To: Development Permit Panel
From: Brian J. Jackson, MCIP
Director of Development
Date: October 6, 2011
File: DP 11-561612
Re: **Application by Abbarch Architecture Inc. for a Development Permit at 10600,
10700 Cambie Road and Parcel C (PID 026-669-404)**

**Excerpt from the Minutes from
The Design Panel Meeting**

3. DP 11-561612 – DEVELOPMENT OF A NEW RICHMOND MINI AUTOMOBILE DEALERSHIP

11561612
 OCT 26 2011
 Plan # 3

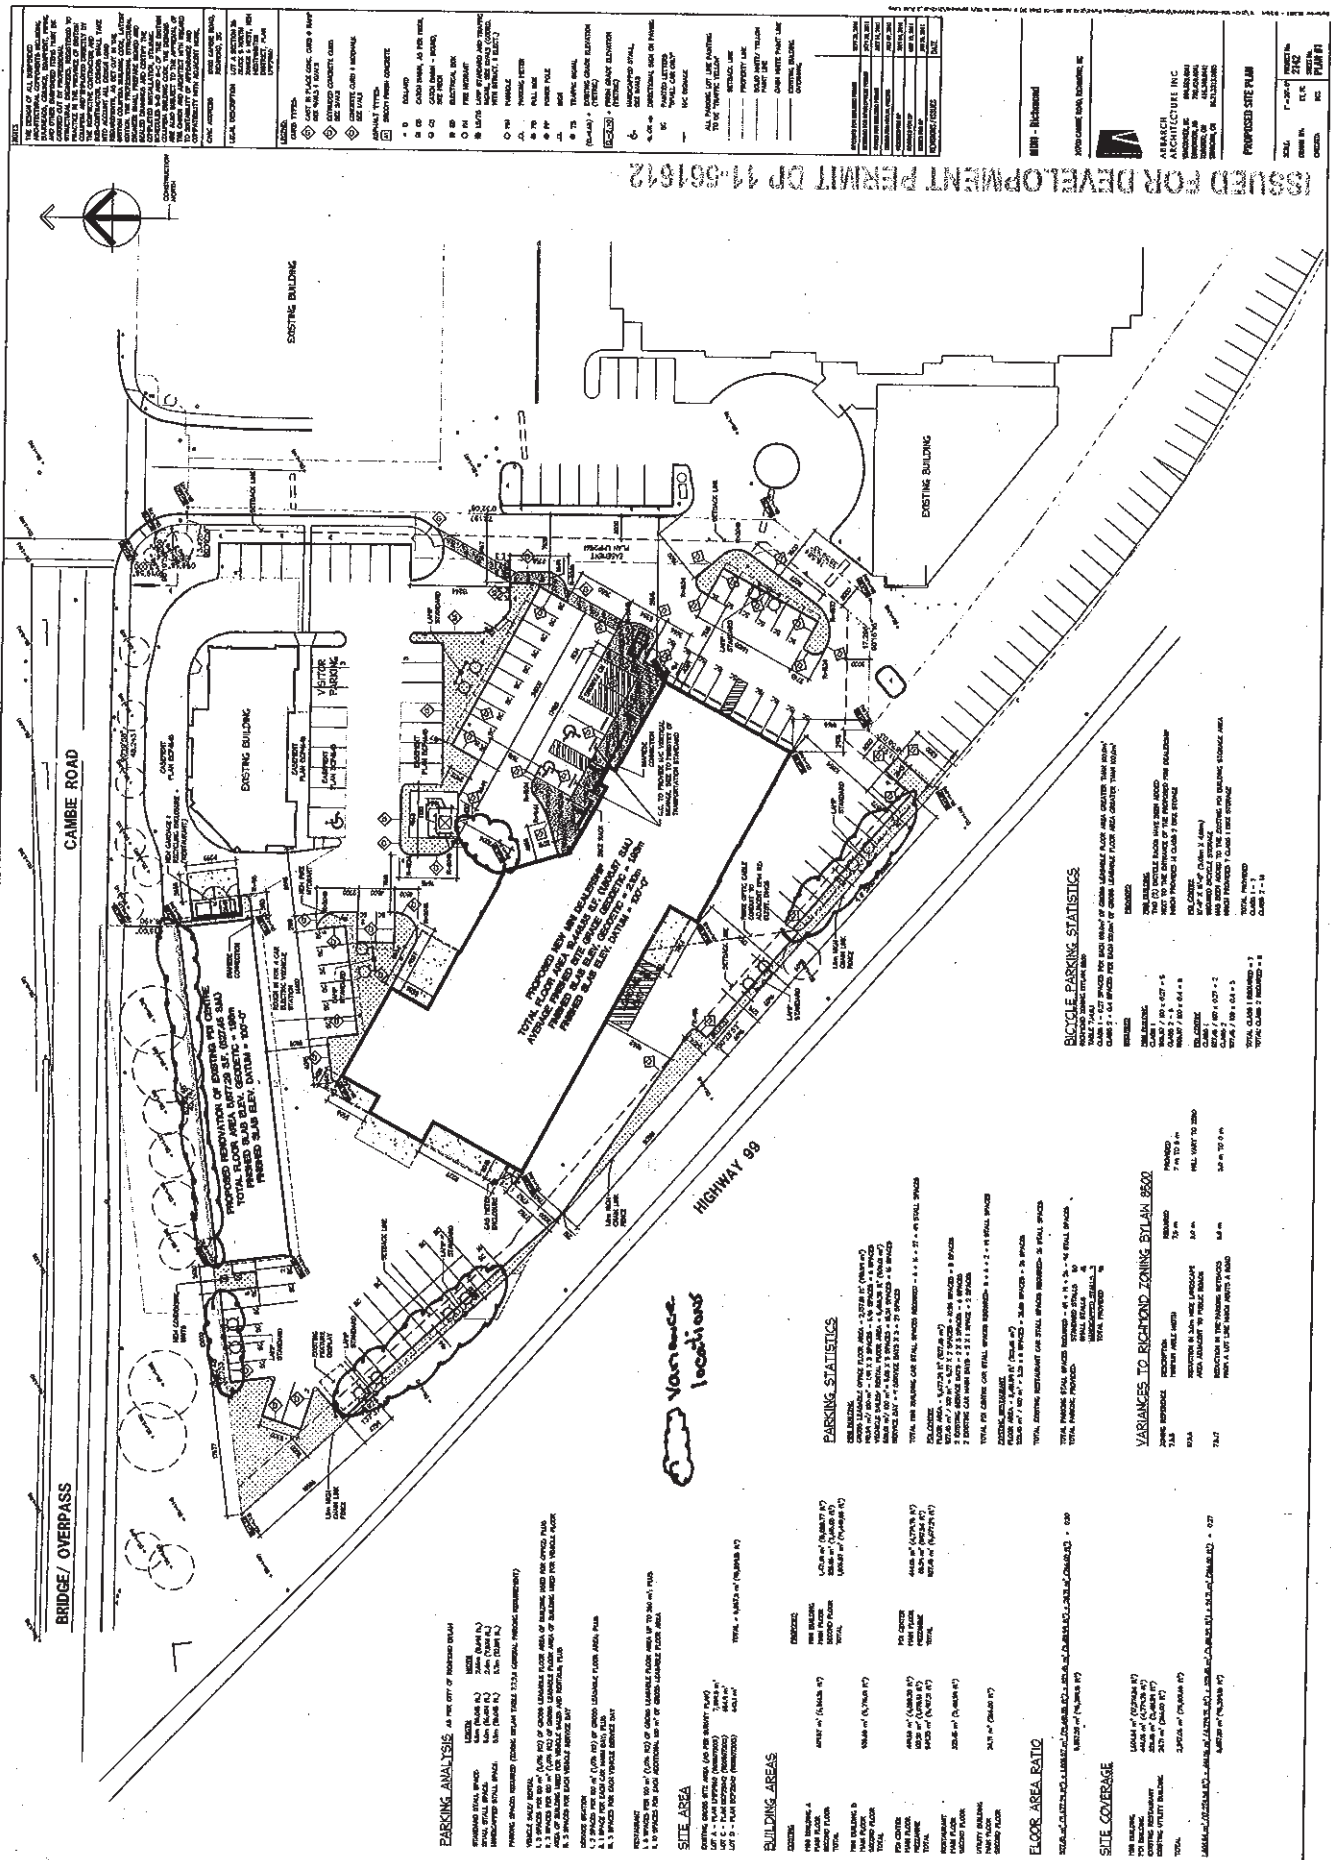
3. consider enhancing the sustainability features of the buildings and landscape elements;

[ABBARCH] Comments by the Panel in regards to enhancing the sustainability features of the buildings and landscape elements have been reviewed and considered by the client and our design team. More plants selections, permeable paving and approximately 160 solar panels have been added to the MINI building and to the site. Please refer to attached Site Plan #1, Landscape Plan #3 and Exterior Elevations Plan #4.

<p>ARCHITECTURE INC. ARCHITECTURE INC. 1000 CAMDEN ROAD, RICHMOND, VA 23262 (804) 281-1111 WWW.ARCHITECTUREINC.COM</p>	<p>PROPOSED PER CENTRE EXTERIOR ELEVATIONS</p>
--	---

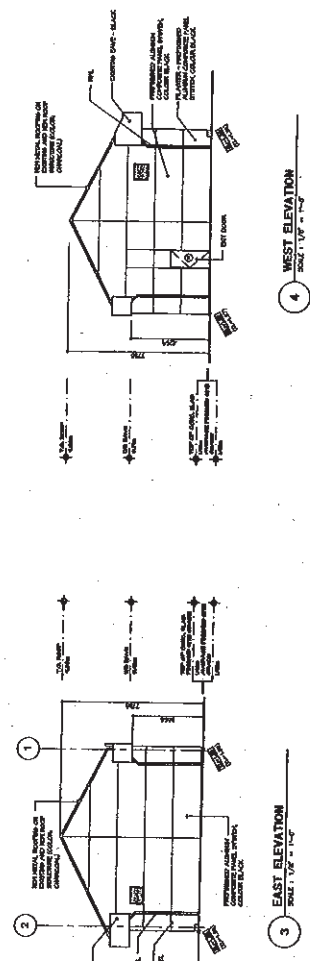
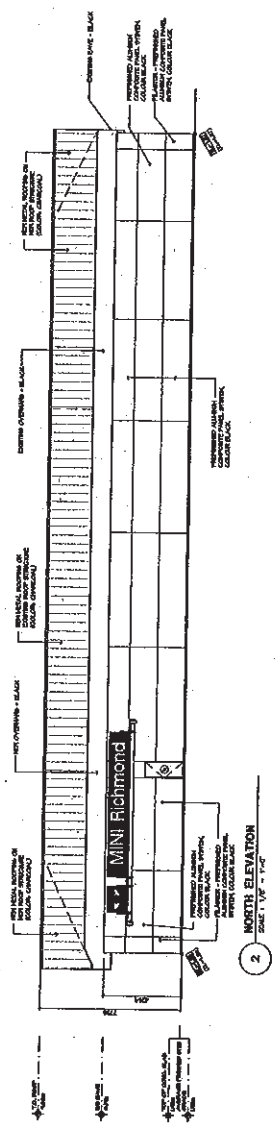
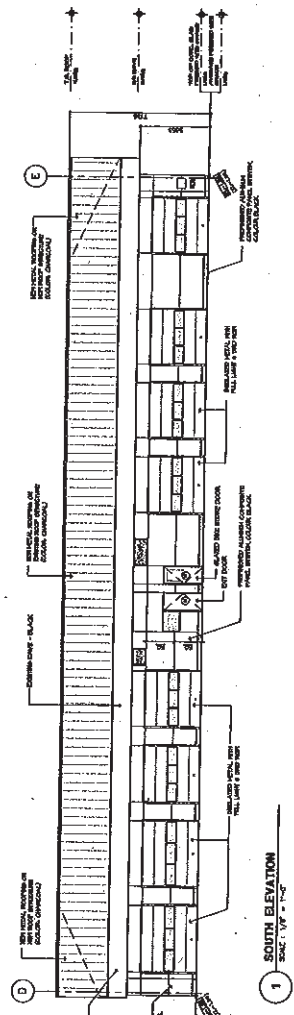
1. design development to the PDI Building: a) enhancing its signage and b) integrating its hipped roof expression with the proposed development;

[ABBARCH] Enhancing the signage is addressed below. Gable ends have been added to each end of the PDI building to give it a more squared off appearance closer to the shape and design of the Mini building. The charcoal colored metal roofing has been carried across the new gable ends so that they blend seamlessly into the overall roof appearance.
